**Subject:** Planning Proposal to amend Hawkesbury Local Environmental Plan 2012 for Jacaranda, Glossodia – consultation under S3.34(2)(d) of the Environmental Planning and Assessment Act 1979

**Subject: EES comments on Planning Proposal to amend Hawkesbury Local Environmental Plan 2012 for Jacaranda, Glossodia – consultation under S3.34(2)(d) of the EP&A Act**

Main Recreational Attractions and Accessibility Plan – source: Appendix V of PPR

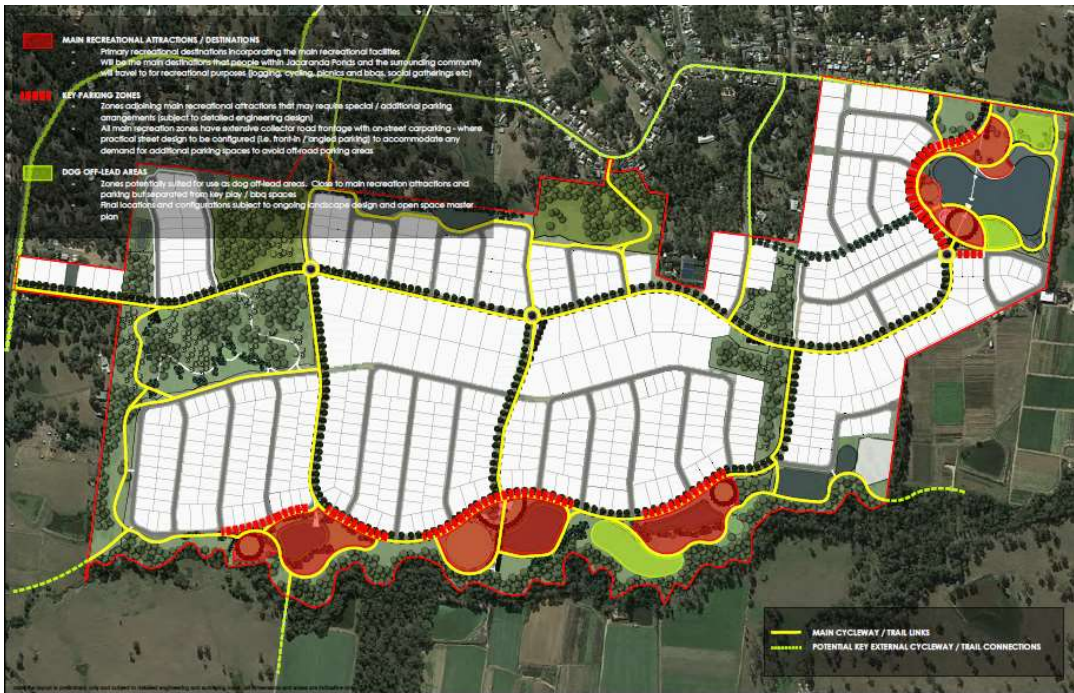
The Main Recreational Attractions and Accessibility Plan notes key parking zones adjoin the main recreational attractions that may require special/additional parking arrangements (subject to detailed engineering design) and that all main recreation zones have extensive collector road frontage with on-street carparking.

If the western and eastern biobank sites are proposed to be used as a “major open space and recreation node” or “key open space and community destination” it is unclear from Figure 20 (see below) where car parking is proposed to be located and whether it is to be on-street parking.

The Main Recreational Attractions and Accessibility Plan (see above and Appendix V of PPR - page 911 of 997) shows one of the potential off leash dog leash areas in the Lake Park adjoins the lake foreshore area. EES recommends the off-leash areas are set back from the lake foreshore area to allow native fauna such as waterbirds, ducks etc access to foreshore/riparian area for foraging, roosting etc without being chased and disturbed by dogs. EES recommends a control is included in the DCP to this effect.

The Main Recreational Attractions and Accessibility Plan (see above) in Appendix V of the PPR (page 911 of 997)) shows a potential dog off leash area is located in the Village Green which adjoins the Biobank site along Currency Creek. EES in its submission to Council (dated 25 June 2020) recommended the DCP include a control that off leash and on leash dog exercise areas must not adjoin the Biobank sites to avoid potential impacts and disturbance of native fauna. The DCP has not addressed this. EES recommends the DCP includes a control to this effect (see comments on DCP below).

Figure 2 – extract from Jacaranda Concept Masterplan (DCP)

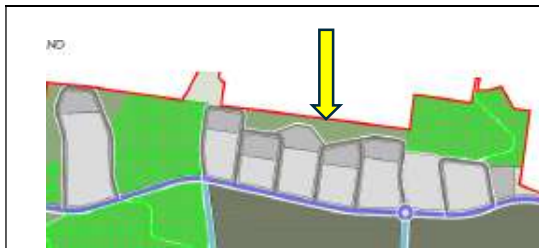
A number of figures in the DCP, including Figure 2 (Jacaranda Concept Master Plan), Figure 3 (Character Areas Structure Plan), Figure 7 (Movement Network) and Figure 9 (Open Space Network) show an open space /green recreation area is proposed along the northern boundary between the two northern biobank areas. The proposed Land Use Zoning Map (figure 33), in the PPR however shows this area is proposed to be zoned R5.

EES recommends the key to Figure 2 is amended to include:

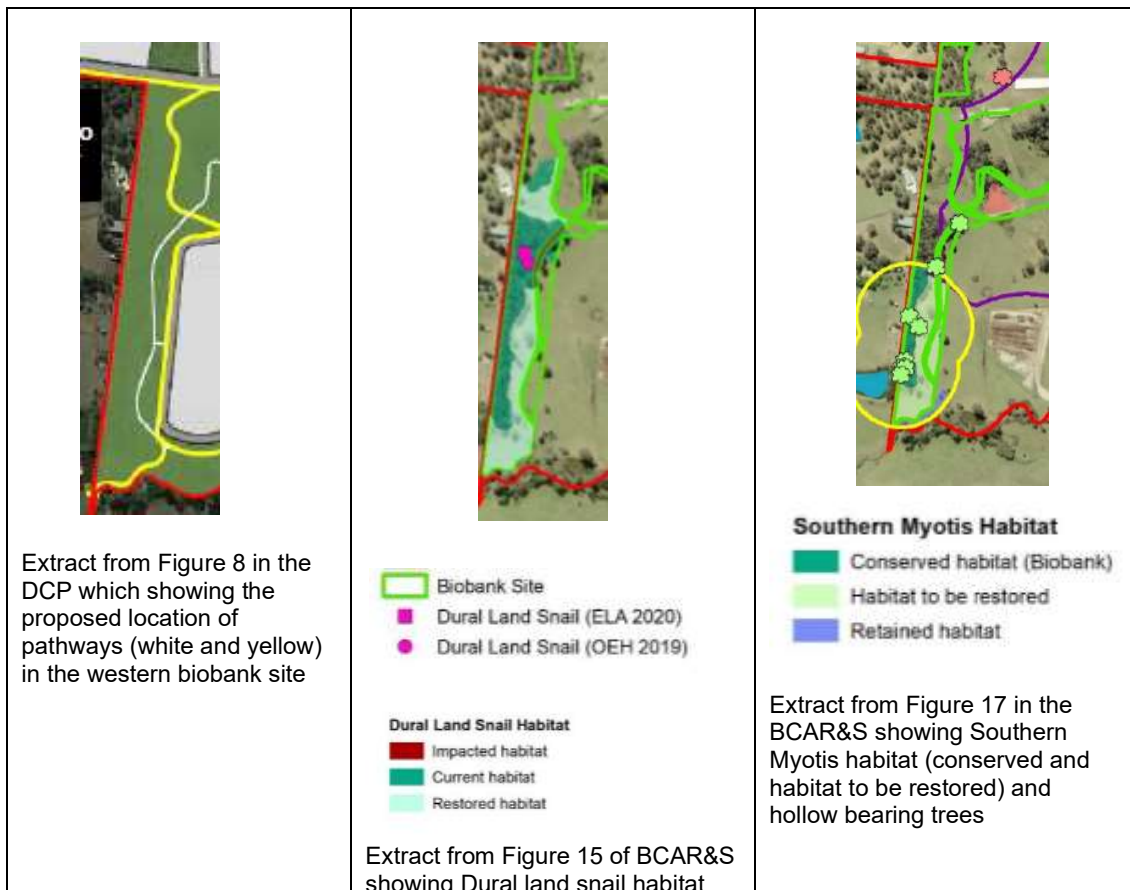
EES notes the proposed inclusion of Objective O.1 “to conserve the remaining high and very high value native vegetation and biodiversity within Jacaranda” in the DCP. The high value native vegetation will primarily be protected and conserved by the Biobank sites and the Biobank

agreement. The Biobank Agreement will dictate what is permitted to occur in the Biobank sites. The Biobank Agreement will not permit any uses that are incompatible with conservation values.
